CORPS OF ENGINEERS

2-1-50	CORRECTED DWG. NO. — ADDENDUM NO. 2
REVISION	DATE
DESCRIPTION	
CORPS OF ENGINEERS U. S. ARMY OFFICE OF THE DISTRICT ENGINEER HUNTINGTON, W. VA.	
DRAWN BY: E.S.W.	TUSCARAWAS RIVER LOCAL PROTECTION PROJECT MASSILLON, OHIO SIPPO CREEK PUMP STATION LOCATION PLAN & PROFILES
TRACED BY: L.L.L.	
CHECKED BY: M.W.W.	
APPROVED BY: J. E. Johnson	
DATE: DEC. 1949	DATE: DEC. 1949
SCALE: AS SHOWN	SPEC. NO.
DRAWING NUMBER 0271-PM-51.3/1	SHEET 25 OF 42

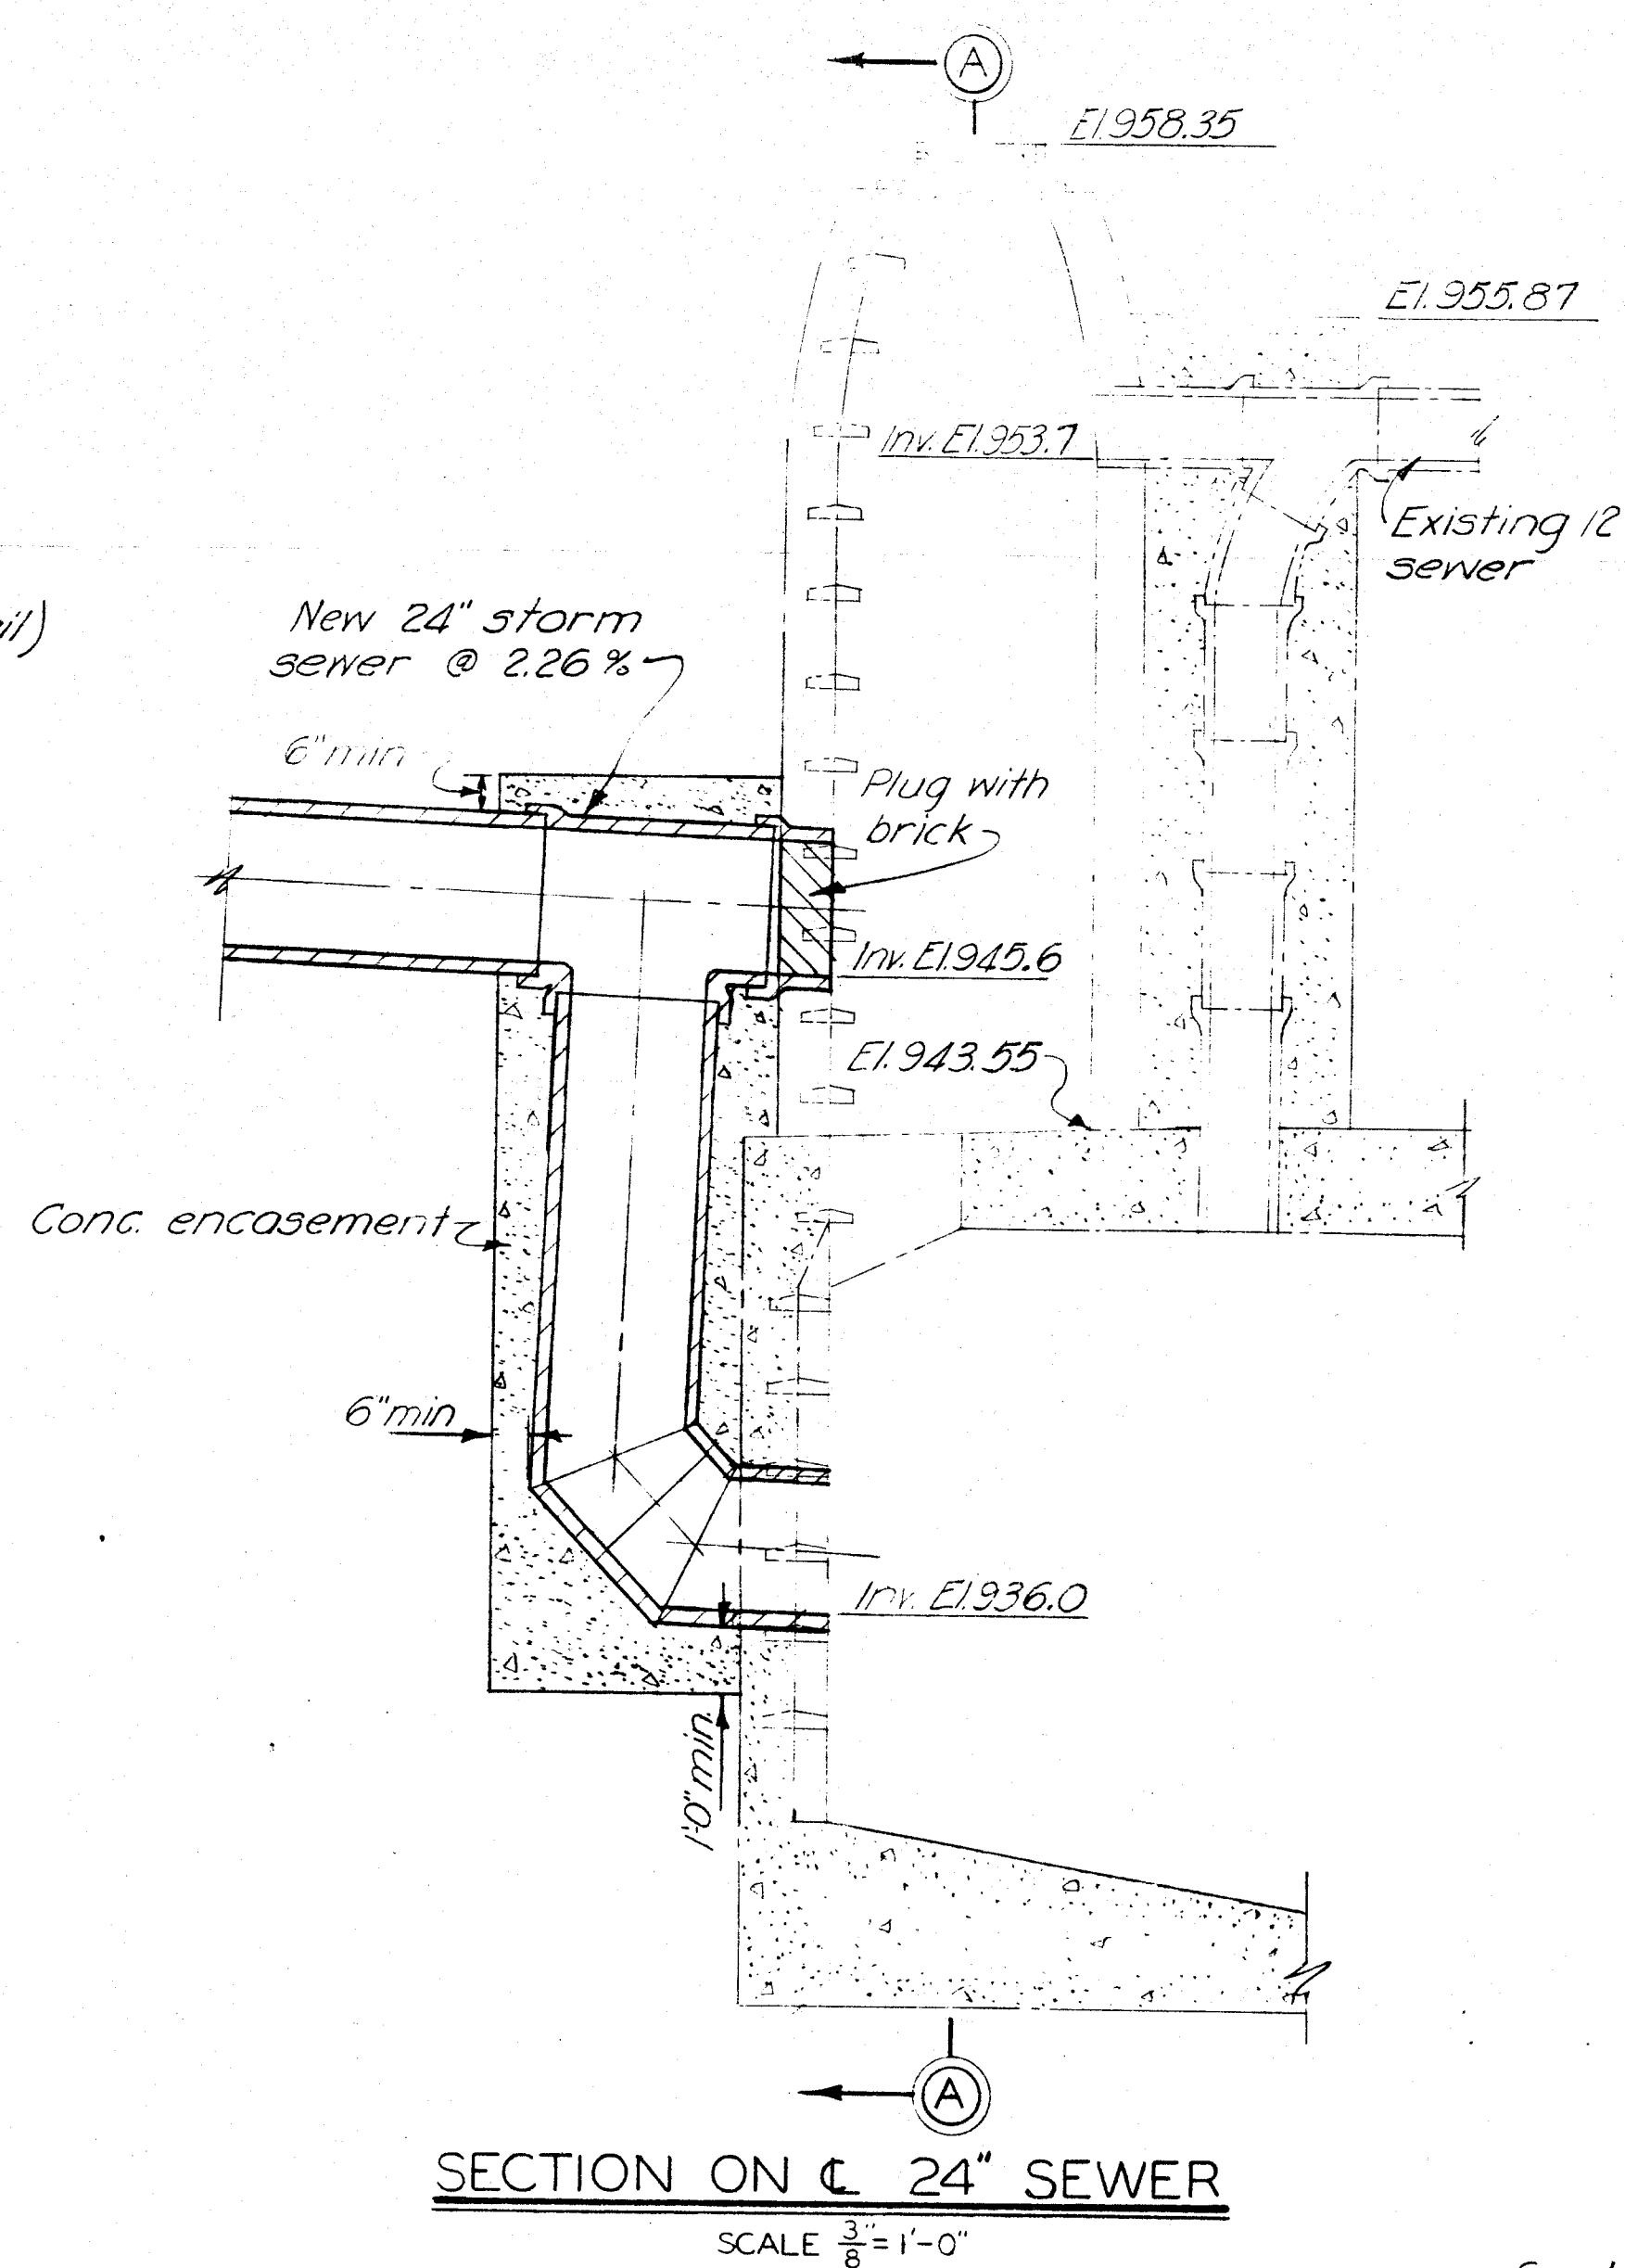
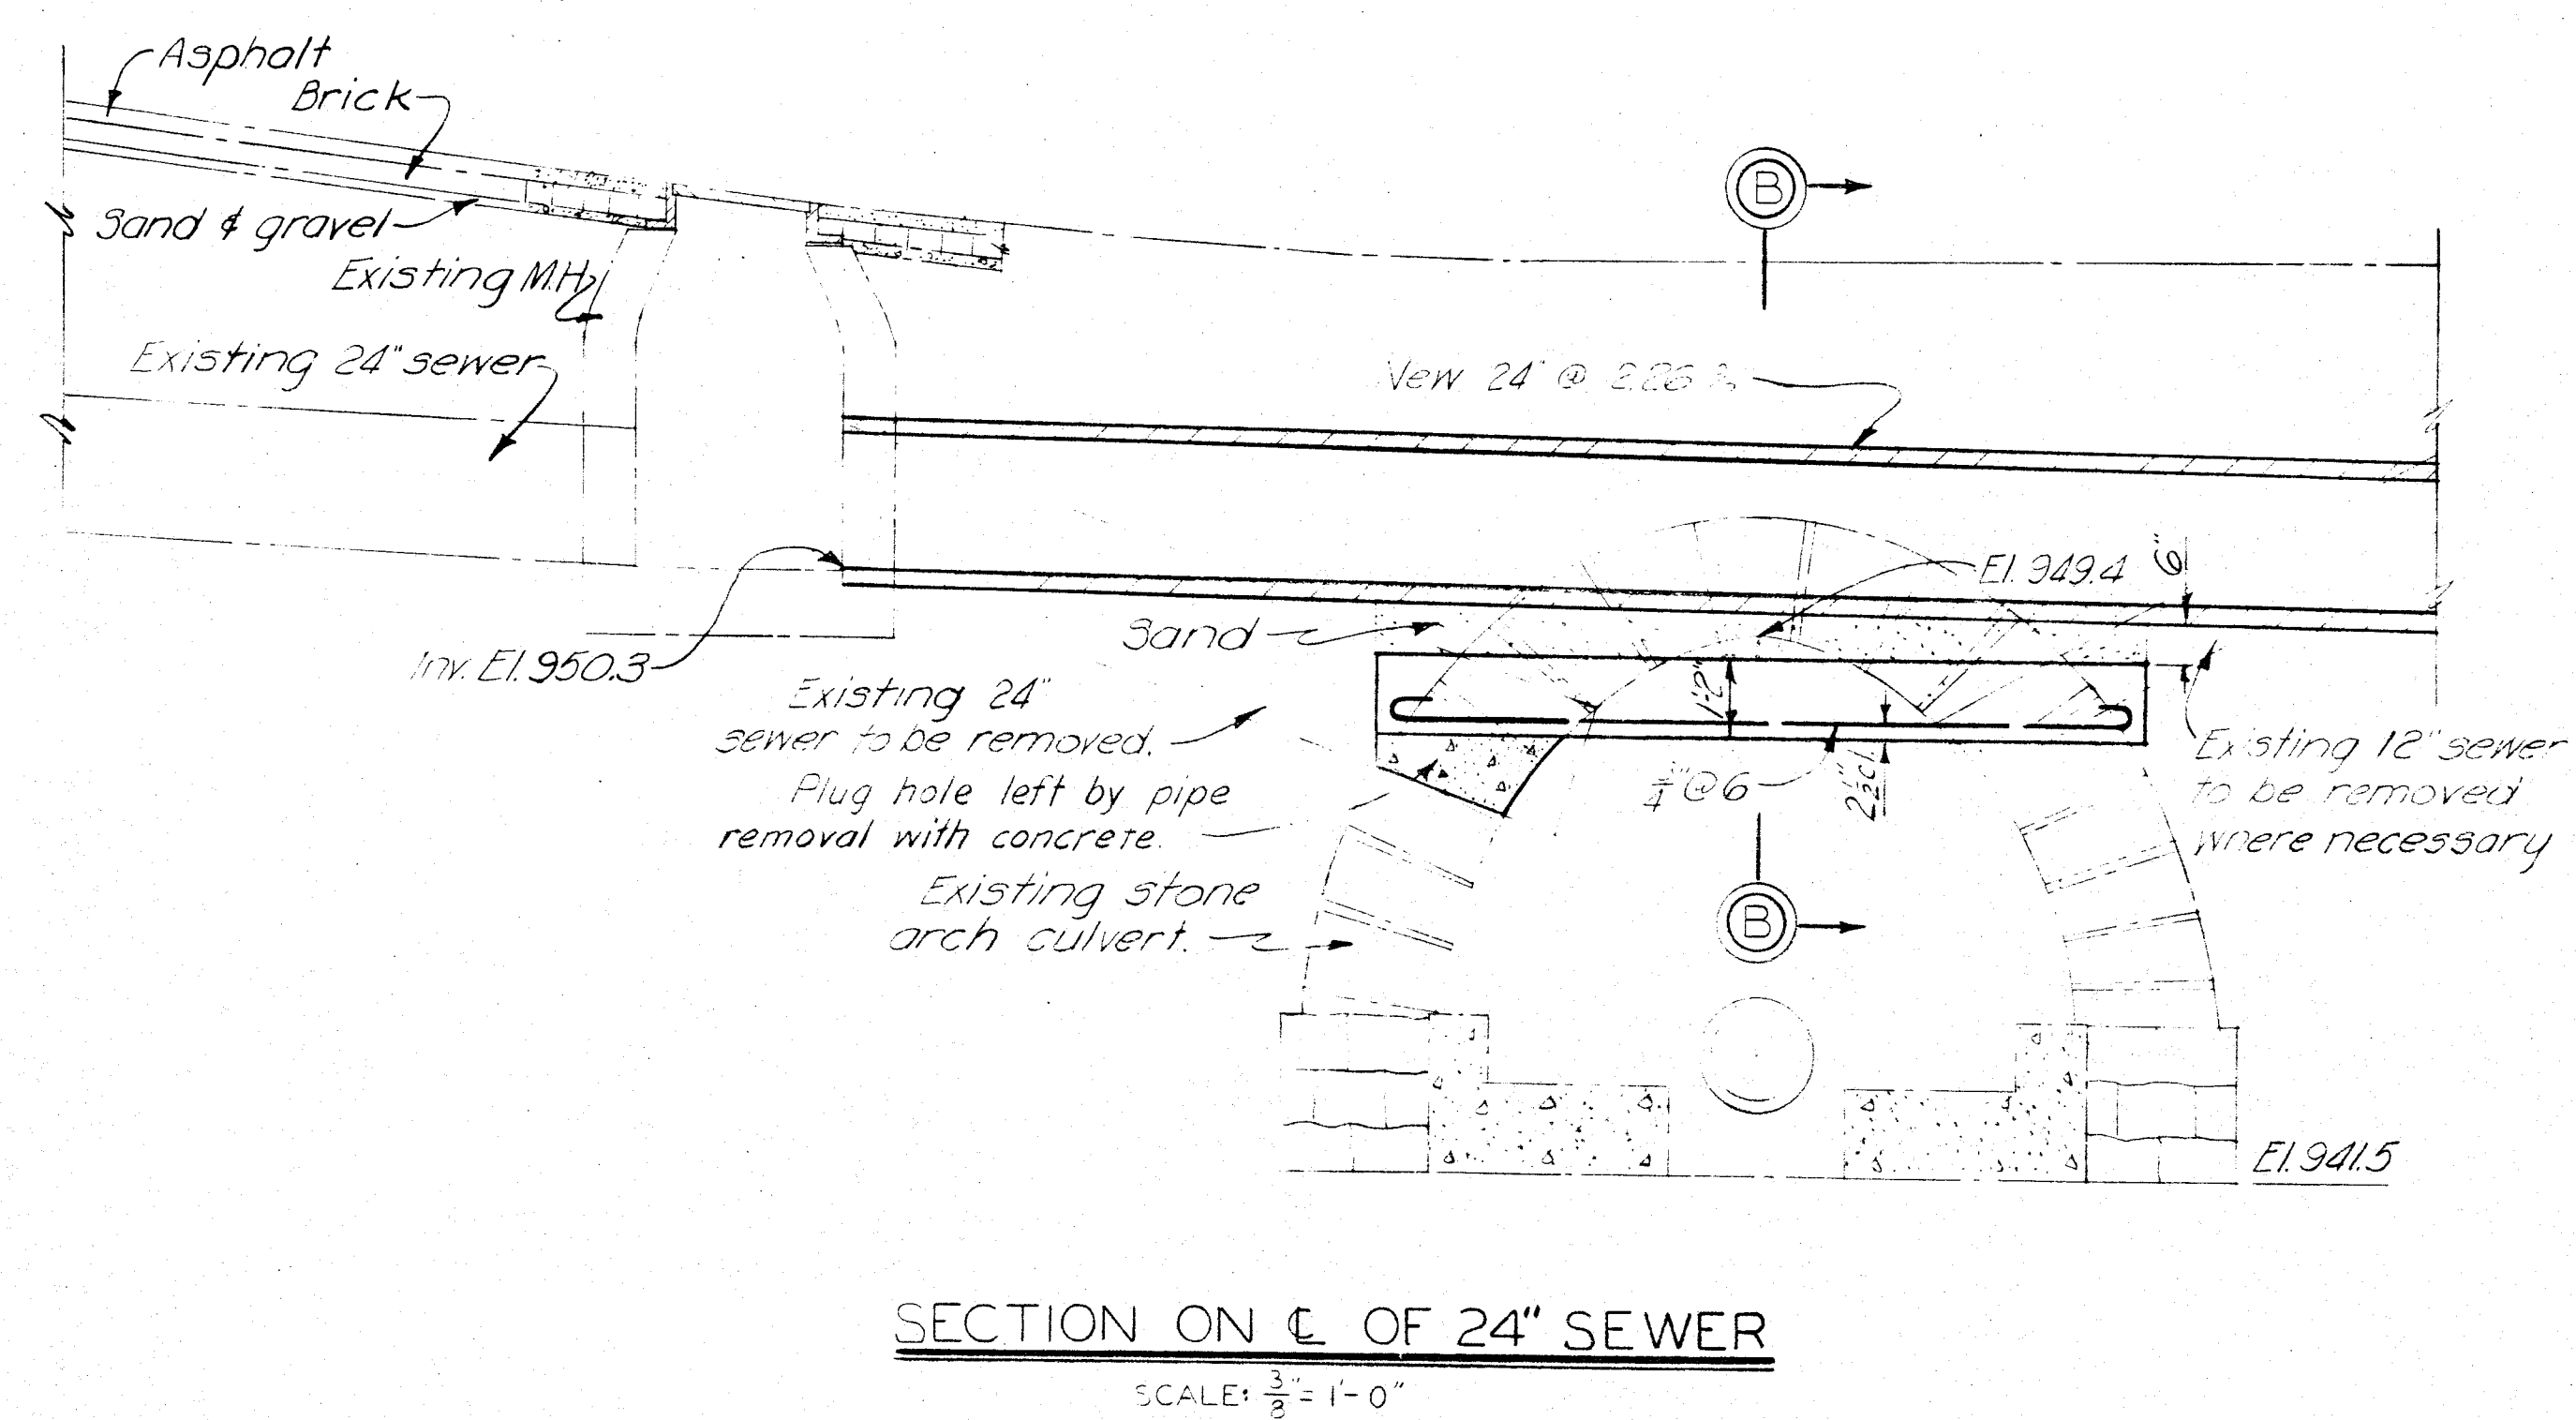
2-1-50	ADDED ELEVATIONS OF TOP OF GROUND AND INVERT OF SEWER - ADDENDUM NO. 1	K.S.B.
REVISION DATE	DESCRIPTION	BY
CORPS OF ENGINEERS U. S. ARMY OFFICE OF THE DISTRICT ENGINEER HUNTINGTON, W. VA.		
TUSCARAWAS RIVER LOCAL PROTECTION PROJECT MASSILLON, OHIO SIPPO CREEK PUMP STATION ALTERATIONS		
DRAWN BY: E.W.H.-L.L.L.	DATE: DEC. 1949	
TRACED BY: L.L.L.	SPEC. NO.	
CHECKED BY: M.D.-M.W.W.	DRAWING NUMBER -513/9
